Evaluation of Physical Barriers – Riverside Downtown Station

Address: 4066 Vine St, Riverside, CA 92507

Evaluation Date: 07-26-2021

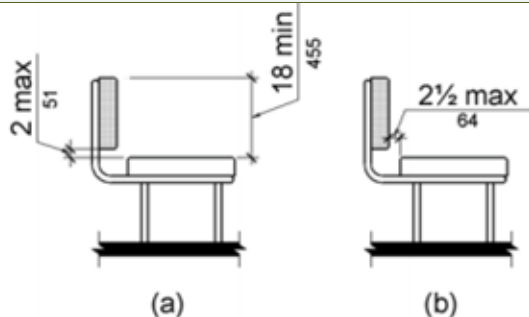
Issues/Barriers Identified	Recommendations	Comments /ADA Requirements											
<div><div><div>i.</div><div>At pedestrian rail crossing in the middle of North loading platform, the ramp slope exceeds 1:12 (8.33%). Slope measured as 8.8 % on one side and 9.6% on the other side. The route was kept closed on the day of evaluation. The ramp is 36 inches wide (not including DWS) with handrails only on one side. The rise is greater than 6 inches.</div><div>Existing ramps do not comply with the then applicable 1991 standards nor with current DOT or 2010 ADA standards for ramps.</div></div><div><div></div><div></div></div></div> <div><div><div>Remove handrails and replace the ramps with walkways no more than 1:20 slope.</div><div>Note: Safe Harbor <u>does not</u> apply as the ramp slope requirements in 1991 and 2010 ADA standards are the same</div></div></div> <div><div><div><div>DOT and 2010 ADA Standards: 405.2 Slope. Ramp runs shall have a running slope not steeper than 1:12. EXCEPTION: In existing sites, buildings, and facilities, ramps shall be permitted to have running slopes steeper than 1:12 complying with Table 405.2 where such slopes are necessary due to space limitations.</div><div><div><div>Table 405.2 Maximum Ramp Slope and Rise for Existing Sites, Buildings, and Facilities</div>

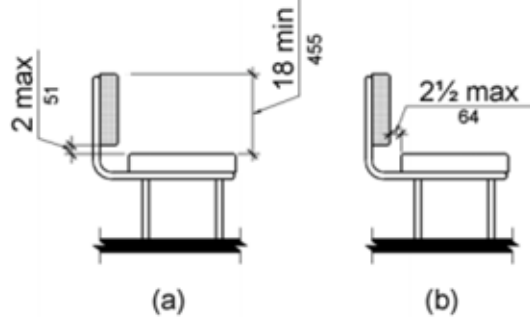
<p>b. Mini High Platforms</p>		
<p>i. The wide ramp at rail crossing (towards SOC) has a cross slope exceeding 2% (3.3%)</p> 	<p>Repair cross slope.</p>	<p>403.3 Slope. The running slope of walking surfaces shall not be steeper than 1:20. The cross slope of walking surfaces shall not be steeper than 1:48 (2%)</p>

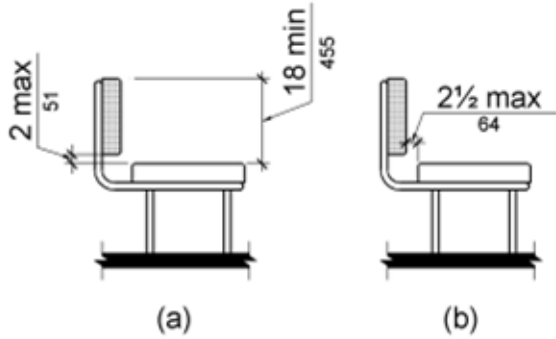
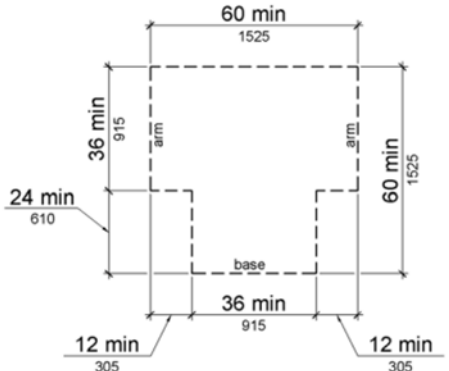
Issues/Barriers Identified	Recommendations	Comments /ADA Requirements
<p>b) Flange gap is slightly higher than 2 1/2"</p> 	<p>Flangeway filler needs to be replaced/maintained</p>	 <p>Figure 810.10 (Exception) Track Crossings</p>
<p>6. Amenities</p>		
<p>a) TVM's</p> <p>TVM's are not in RCTC's scope. However, they are considered as being compliant to ADA requirements per information found on website https://metrolinktrains.com/ticketsOverview/where-to-buy/ticket-machines/</p> 	<p>Adequate clear space is provided at TVM's. No action.</p>
